PARTS & SERVICE NEWS

REF NO.	AT02089A
DATE	Sep. 11, 2003
(C) Page 1 of 11

SUBJECT: REPAIR PROCEDURE OF A/C COMPRESSOR ADJUSTMENT ROD & PULLEY COVER ON HD325, 405-6

PURPOSE: \triangle To introduce modification procedure to repair breakage of the drive belt adjusting rod and cracks in the air compressor pulley cover and in the bracket mounting bolts on HD325-6 and HD405-6 dump trucks

A. Contents of the modification of the adjusting rod

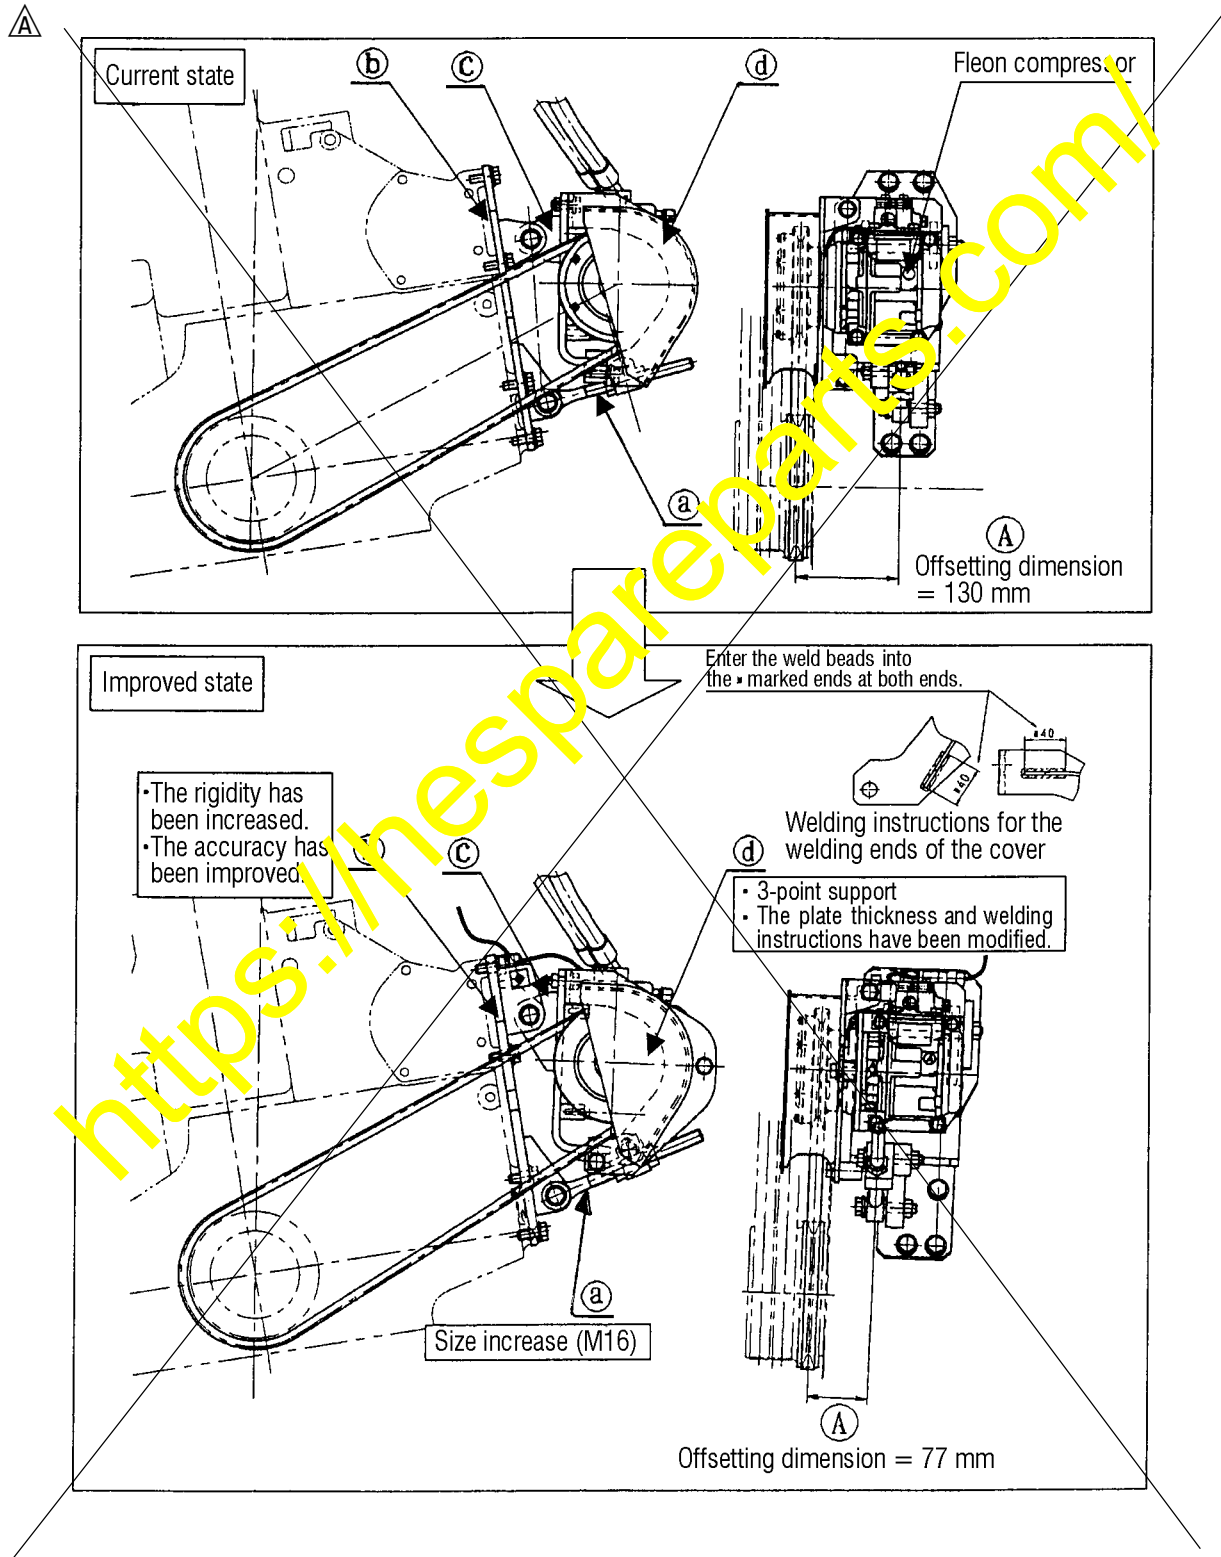
The bending stress being applied to the adjusting rod is to be reduced to increase the durability of the adjusting rod.

- 1) The offsetting dimension between the adjusting rod and the drive belt is to be reduced. (Dimension \textcircled{A} 43 mm \rightarrow 77 mm)
- 2) The adjusting rod \textcircled{a} is to be reinforced. (Size increase: M14 \rightarrow M16)
- 3) The rigidity of the brackets \textcircled{b} and \textcircled{c} is to be increased. (The cross-sectional shape is to be changed and the sheet thickness is to be increased t 9 \rightarrow t 12)
- 4) The accuracy of the brackets \textcircled{b} and \textcircled{c} is to be improved. (Tolerance for the shape is to be additionally instructed.)

B. Contents of the modification of the adjusting rod

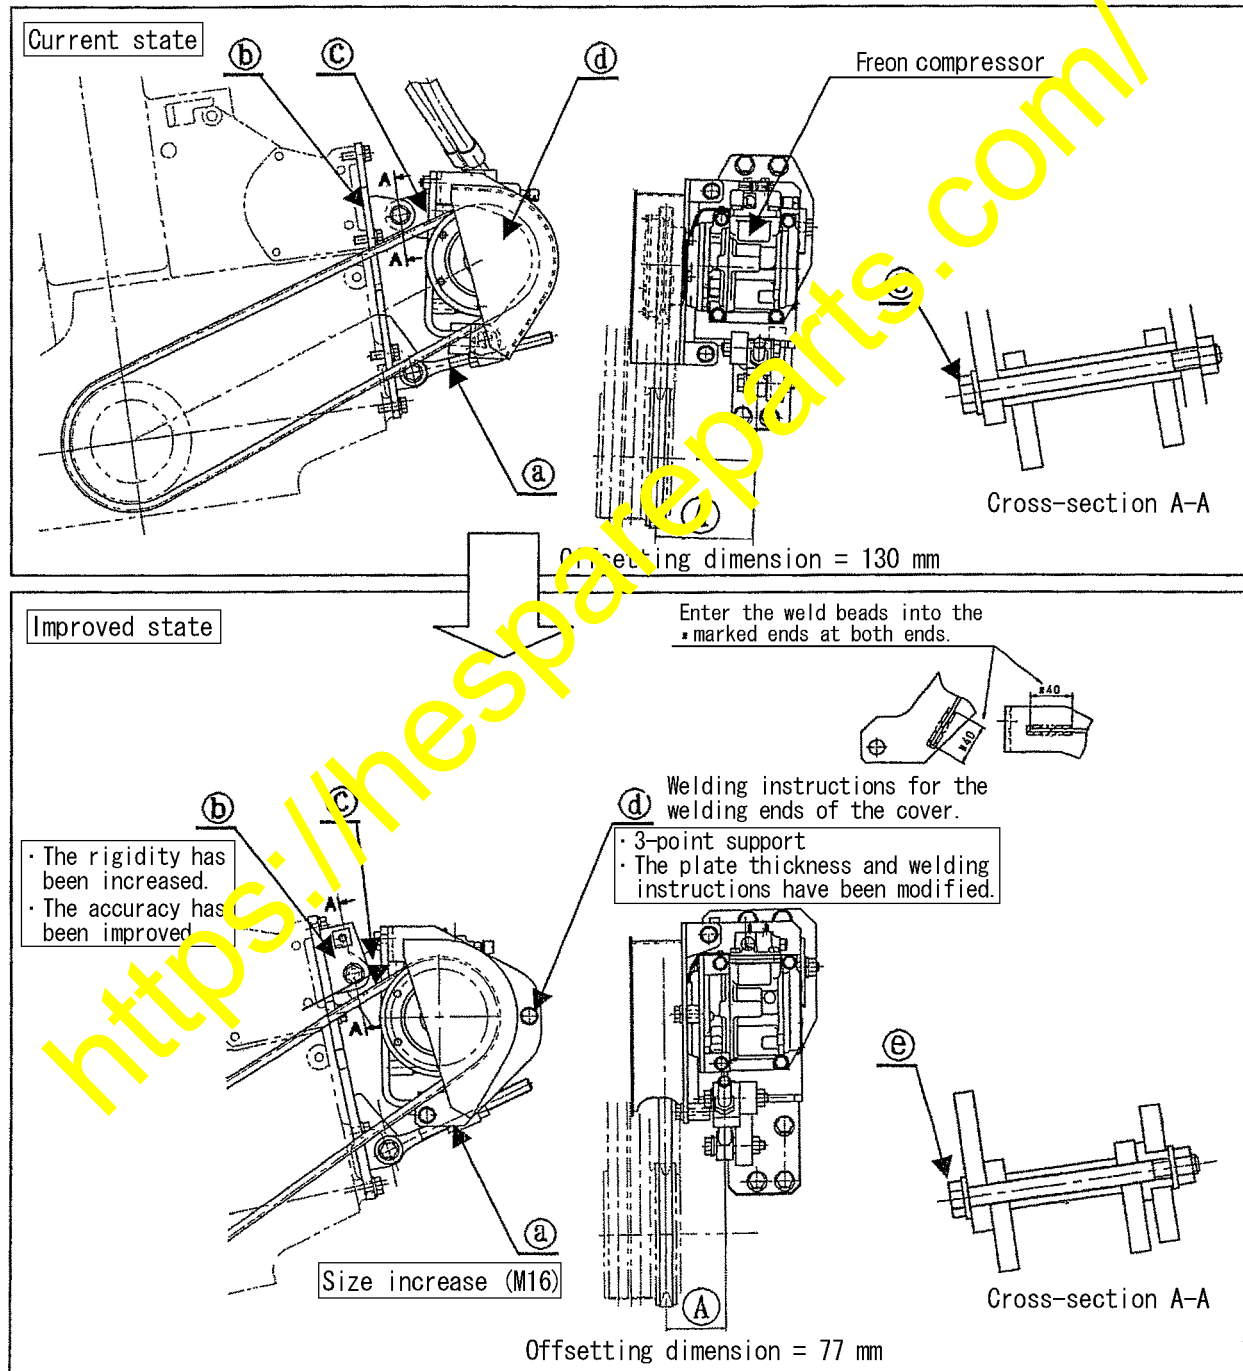
The influence of the vibrations of the engine is to be reduced to increase the durability of the pulley cover.

- 1) The supporting method for the pulley cover $\text{\textcircled{a}}$ is to be changed from the current 2-point support method to a 3-point support method.
- 2) The strength of the pulley cover is to be increased.
 - Sheet thickness increase: $t\ 2.3 \rightarrow t\ 3.2$

Fig. 1

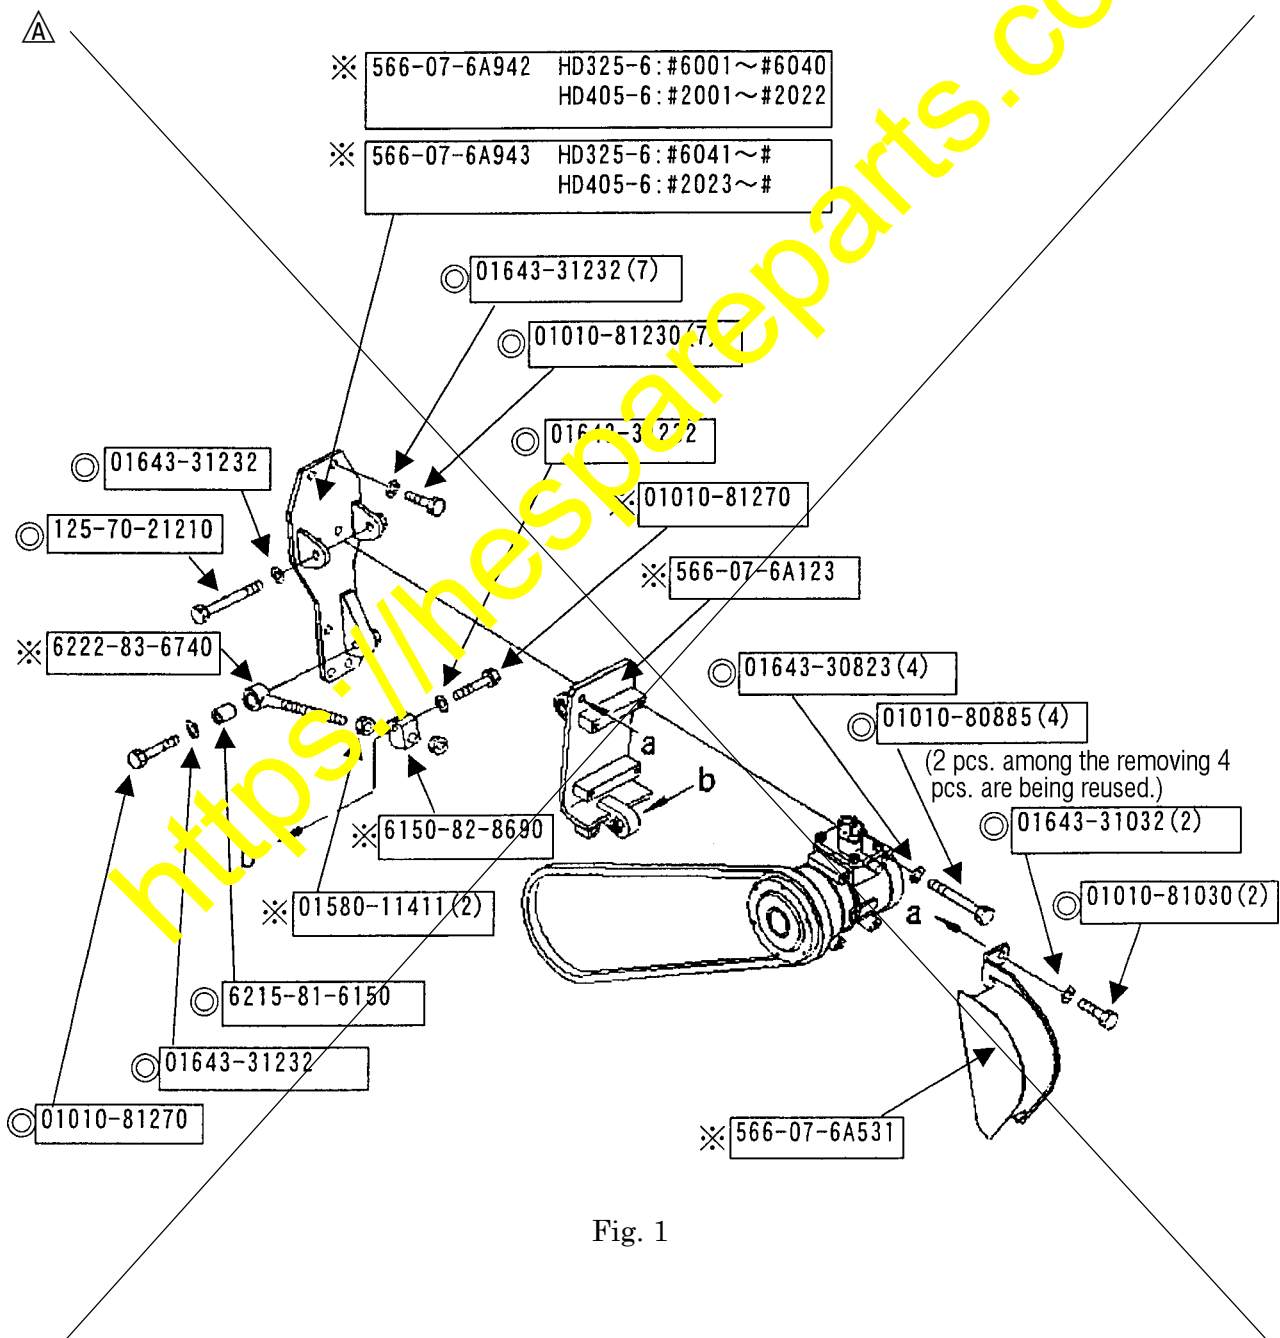
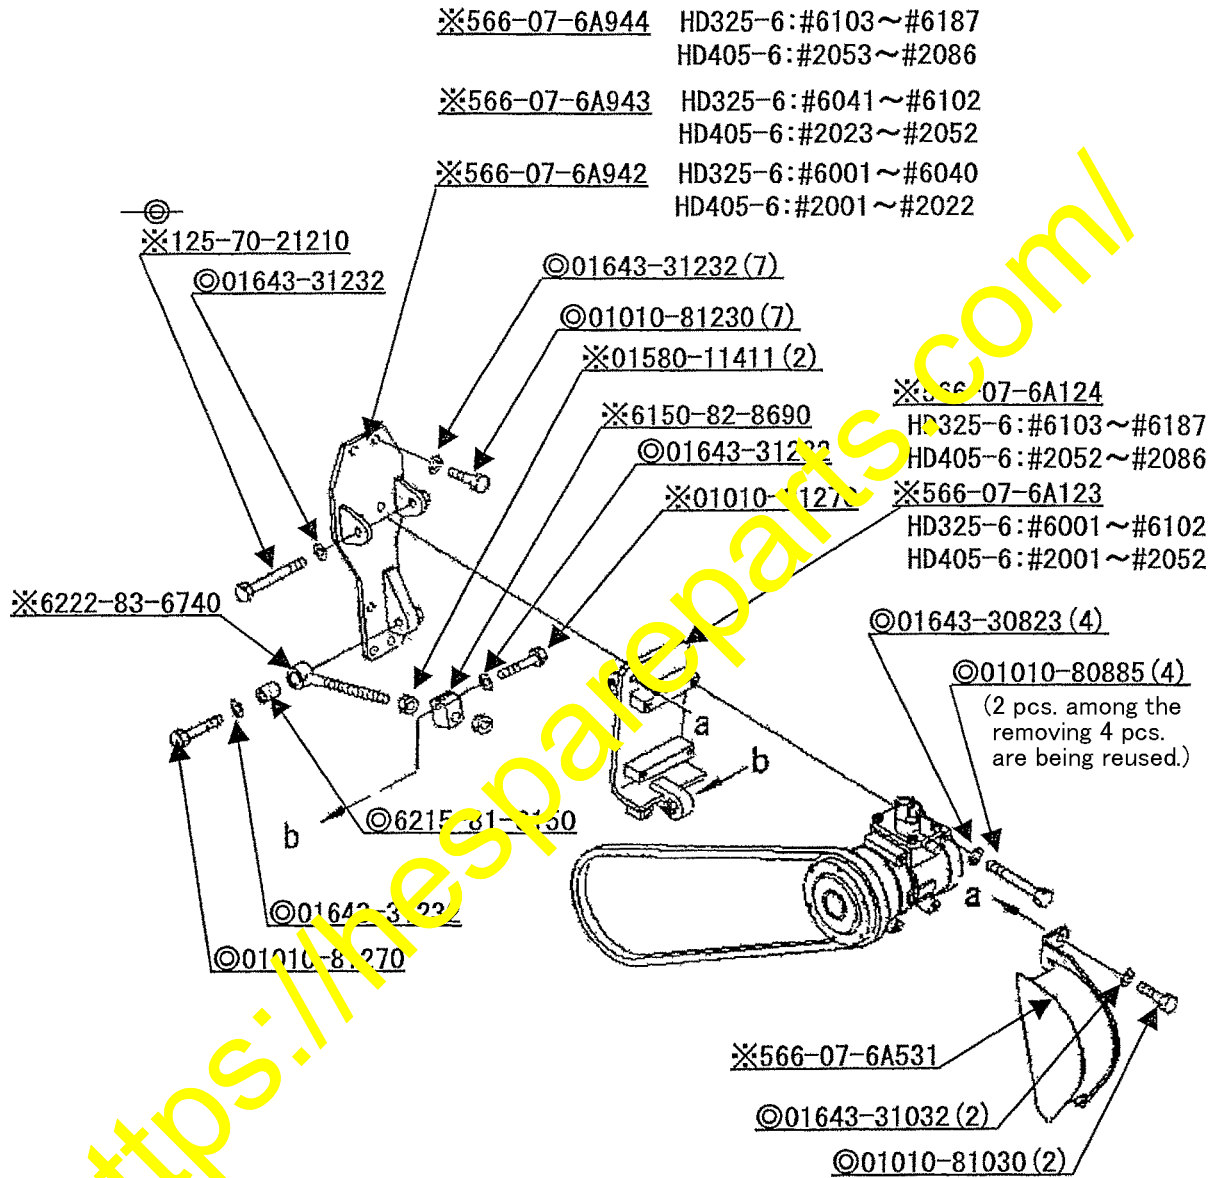
Remove the parts marked  and  in the drawing below. (Refer to Fig. 1.)

Since the parts marked  are being reused when installing the improved parts, store them carefully.

Parts marked  are to be replaced with the newly prepared parts.
